ADDENDUM #3: OCTOBER 30, 2019
Rosedale Sanitary Sewer Replacement Project
Alleghany County, Virginia
Engineer's Project No. 10171

**ROSDALE
 SANITARY SEWER
 REPLACEMENT
 PROJECT**
 ALLEGHANY, VIRGINIA

**MH11-MH10 AERIAL
 CROSSING EXHIBIT**

SHEET NO.
EXHIBIT A

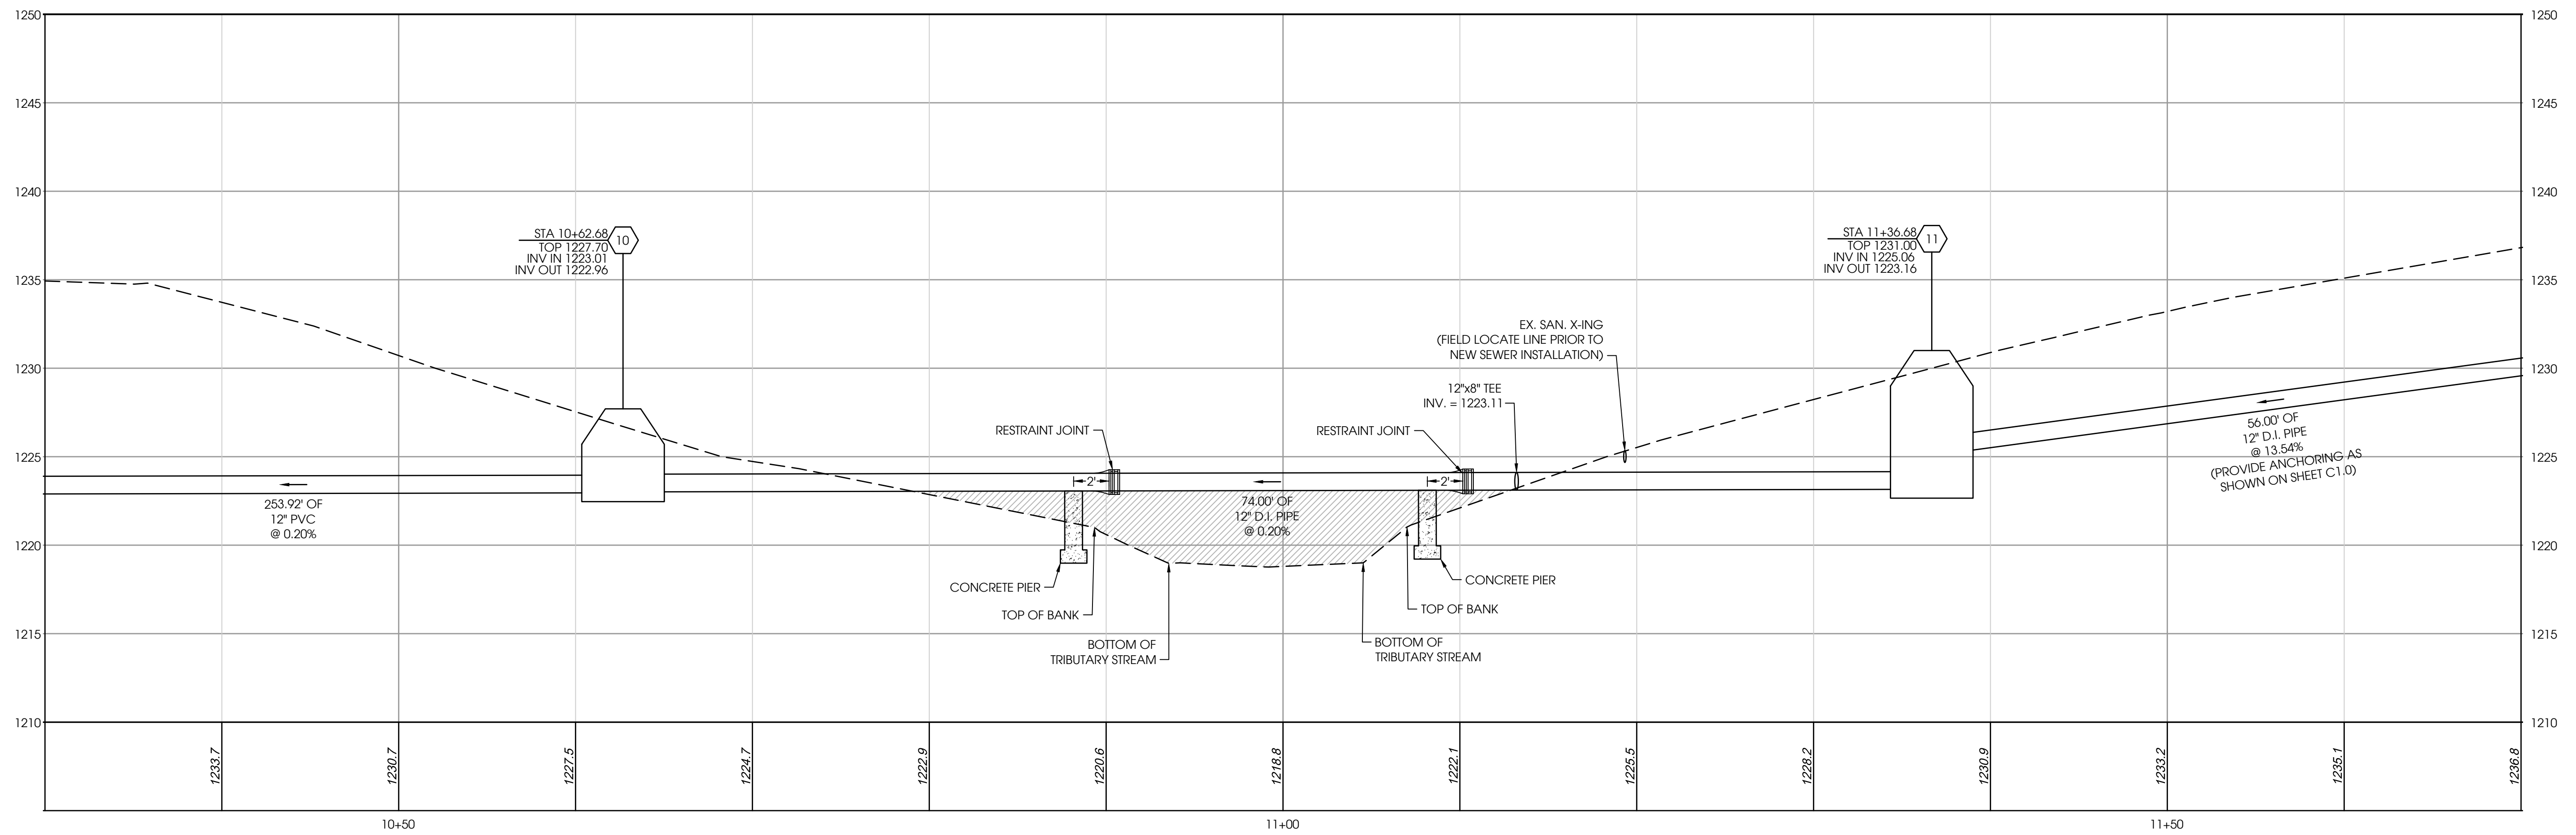
1. Note #4 says the quantity of piers every 20' or as directed by the engineer. Do you have a quantity or location for these piers? **Refer to the attached "EXHIBIT A" drawing which shows the MH #11 - MH #10 Aerial Crossing alternate. Contractor shall include two (2) piers that will be located on each side of the banks of the tributary stream (approximately 18 +/- ft. apart). Also, the Contractor shall utilize 20 ft. lay lengths of ductile iron pipe across the span of the piers.**

1. Attached is a Drawing (“EXHIBIT A”) which shows the MH #11 - MH #10 Aerial Crossing alternate. This information is related to the “Deduct/Alternate Price” requested in the Bid Form of the DIVISION A work for an aerial crossing across the tributary of Dunlap Creek in lieu of deeper cuts to install the sanitary sewer under the tributary.
